SLI LIGHTING

February 6, 2009

SUBJECT: REQUEST FOR ADDITIONAL INFORMATION - APPLICATION FOR EXEMPT DISTRIBUTION LICENSE

FIGURE No. 1

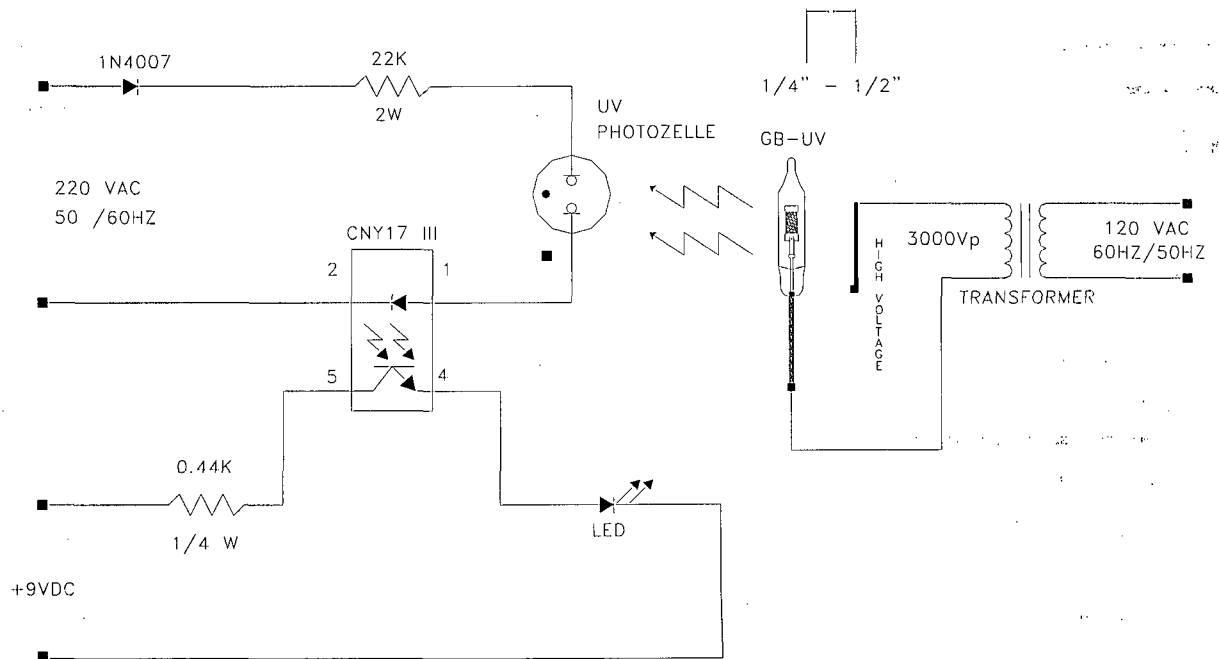
4) Title 10, Code of Federal Regulations, Section 32.14(b)(4) requires procedures for and results of prototype testing to demonstrate that the byproduct material will not become detached from the product and that the byproduct material will not be released to the environment under the most severe conditions to be encountered in normal use of the product. Please provide these procedures and describe the prototype testing performed on the product. **See lamp testing procedures in the attachments**

- A) Connect the UV-Enhancer to a circuit according to the Figure No. 1 on page 3.
- B) The UV-Glowbottle must be 2" far from the UV photocell.
- C) Supply 230-240 VAC - 50 Hz to the UV photocell.
- D) A 9 VDC power supply should be connected to the optoisolator device.
- E) Apply 3 KV to the UV-Glowbottle electrode.
- F) The UV photocell detects the UV discharge and the red LED shall flashe indicating UV-Glowbottle operation.
